GN Docket No. 18-122, *Expanding Flexible Use of the 3.7 GHz to 4.2 GHz Band*

Alion Review of AVSI Report, “Preliminary Report: Behavior of Radio Altimeters Subject to Out-Of-Band Interference”

Alion Conclusions Regarding the AVSI Report

Figure 4: 300 MHz OoBI Waveform Centered at 3850 MHz Pictured on a Spectrum Analyzer.

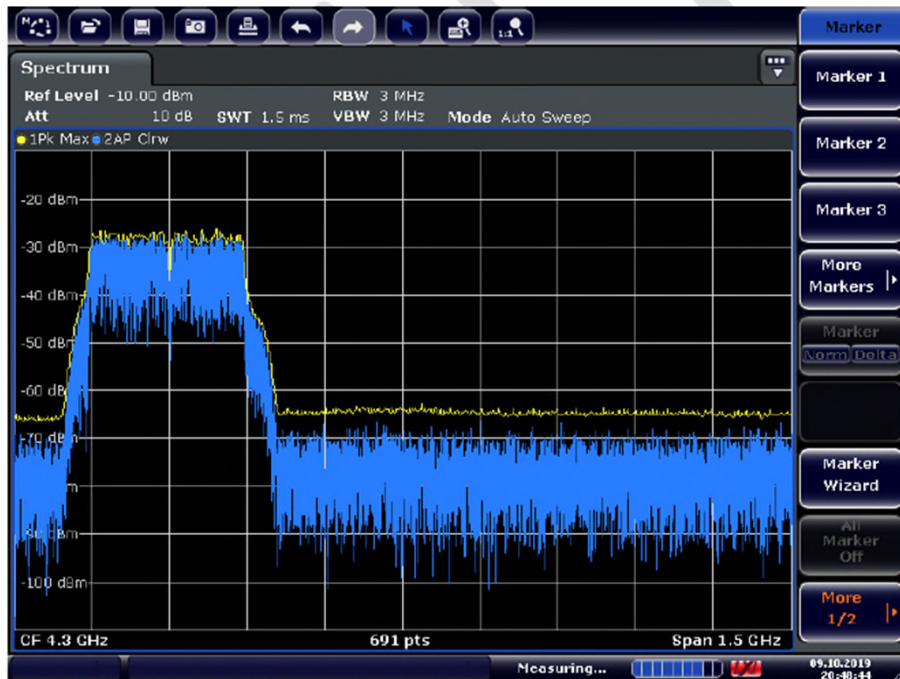
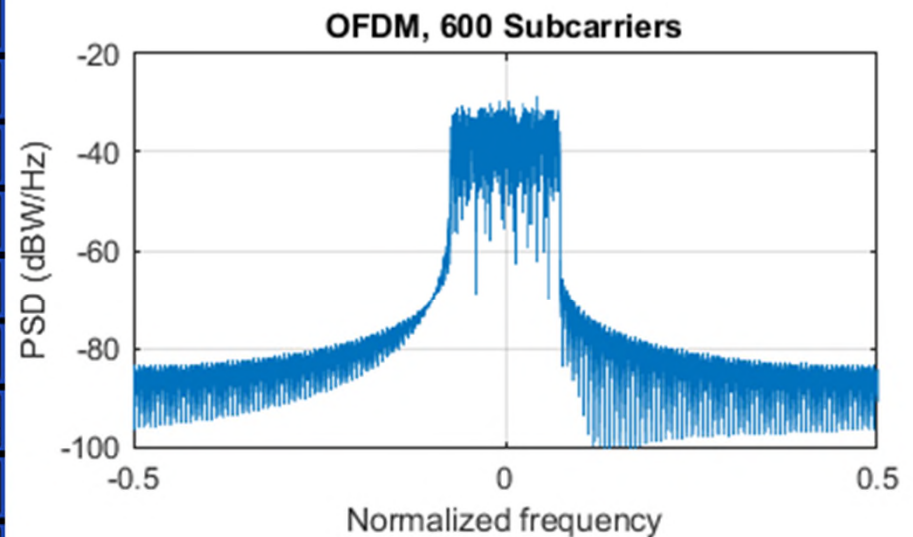
- For the AVSI analysis, a simulated Orthogonal Frequency-Division Multiplexing (OFDM) waveform was generated to characterize the 3700 – 4200 MHz wireless signals. The spectrum analyzer plot of the waveform shows a flattened response approximately 40 dB down from the peak. The OFDM spectrum should roll off more than 40 dB over this frequency range. Shown on the right is the spectrum of a theoretical OFDM waveform.

- The Out-of-Band Interference (OoBI) levels in the analysis would not comply with the emission limits for virtually any services associated with a base station or fixed station governed by FCC rules: Part 27 services, Part 27.53 or Part 96 services, Part 96.41 (e)(i). A follow on study should look at limits associated with these Code of Federal Regulations (CFR) guidelines ($43 + 10\log(P)$, $70 + 10\log(P)$, and the Part 96 limits).
- It appears that the OoBI levels in the analysis were flat. Limits may be flat, but real systems tend to have a roll-off. Investigating the emission spectrum roll-off may be worthwhile.

Figure 8: Aggregate Plot of Altimeter Break Points, 1000 Feet.

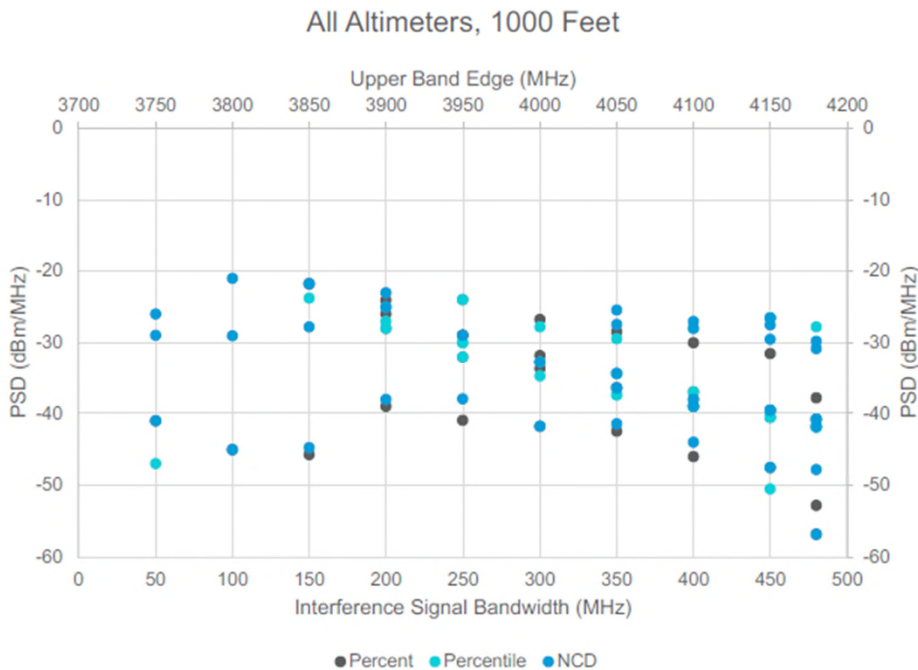
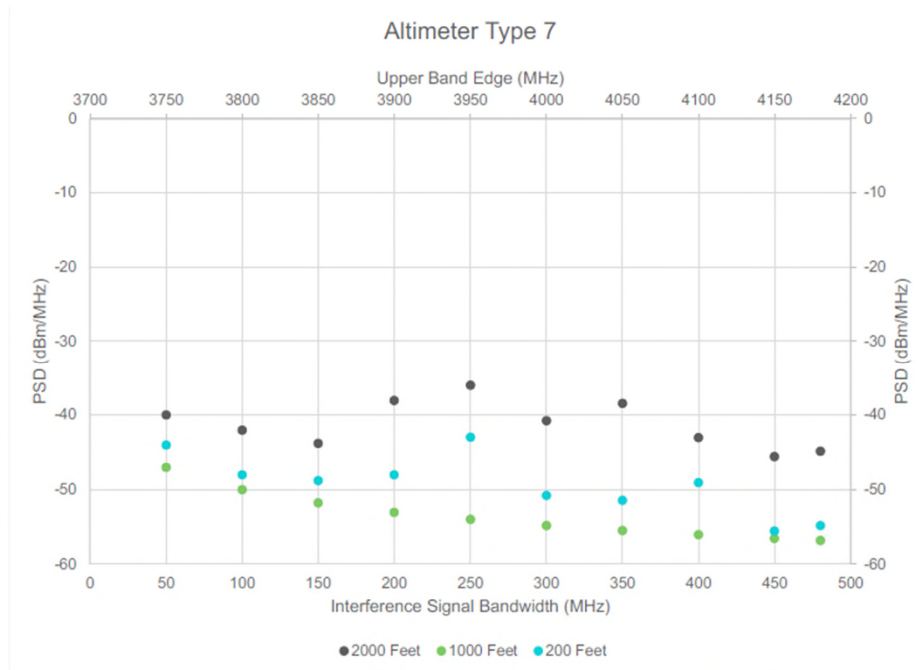
- The 1000 ft. data (Fig. 8) was not consistent with Fig. 11 except for possibly the first and last points (50 and 480 MHz bandwidth).

Figure 7: Aggregate Plot of Altimeter Break Points, 200 Feet.

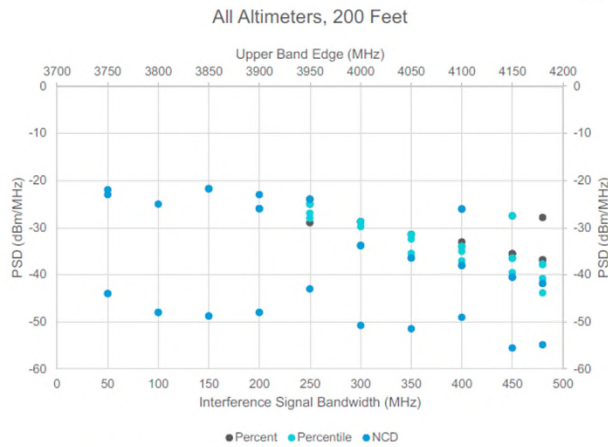
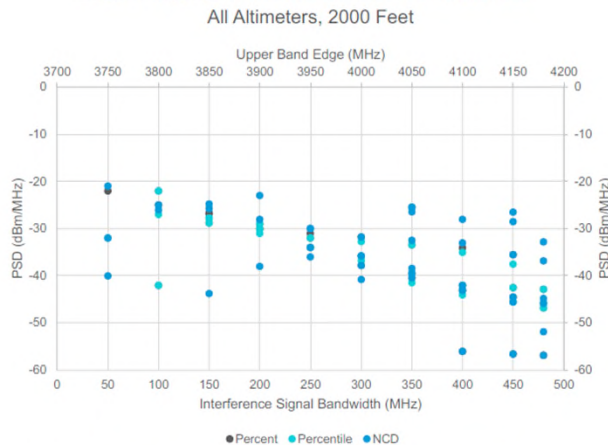
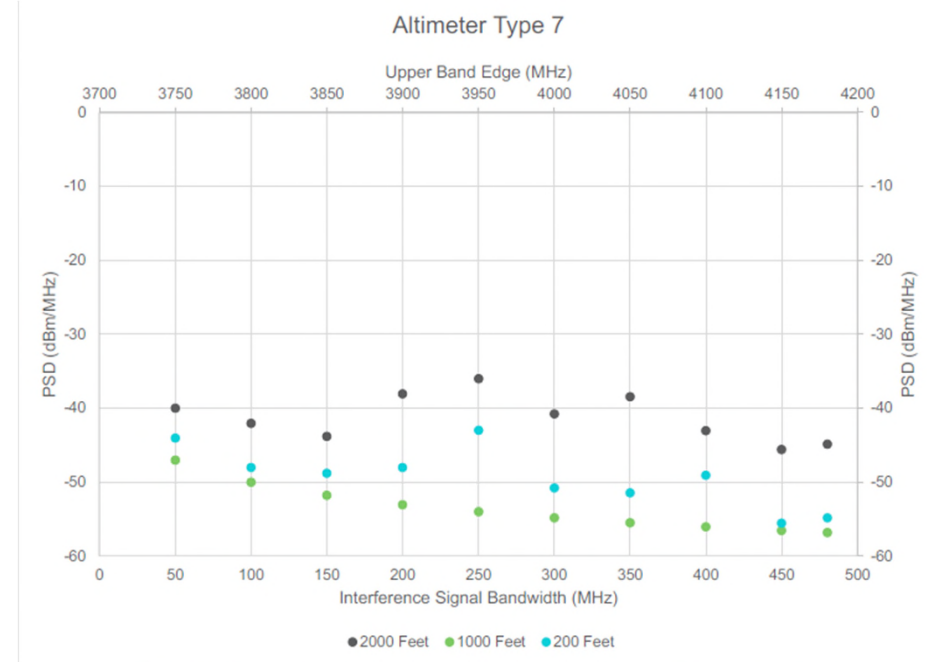
- The 200 ft. (Fig. 7) and 2000 ft. (Fig. 9) data was consistent with Fig. 11. However, the 2000 ft. case showed better performance than the 200 ft. case. It would be expected that the 200 ft. case would perform better due to a higher Signal-to-Noise (S/N). The reduced performance may have been due to in-band RA interference from other aircraft (which applied to only the 200 ft. case). However, this was not seen for RA types 1 through 6.

Figure 8: Aggregate Plot of Altimeter Break Points, 1000 Feet.

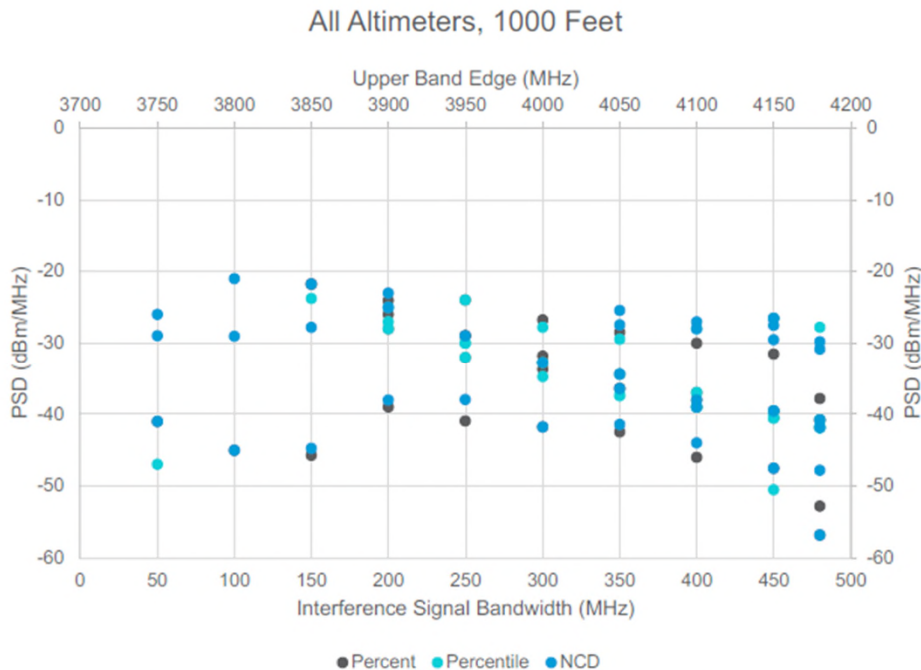
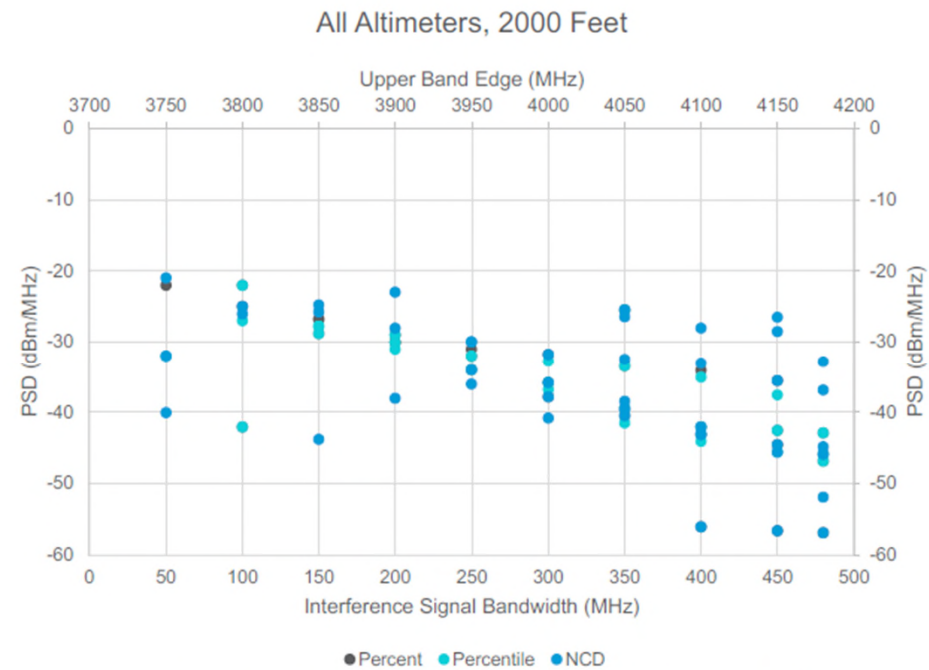
- The analysis measurements reflected 7 types of altimeters. Figs. 8 and 9 showed measurements for up to 9 cases. These may have been repeated measurements for specific altimeters, but it was not mentioned in the text.
